# Shearwater Teric and Tern Firmware Release Notes

## เวอร์ชัน 27 2022-06-01

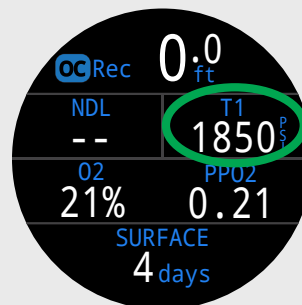
In the OC Rec Standard layout the TTS (top-right) location can be replaced by alternate displays.
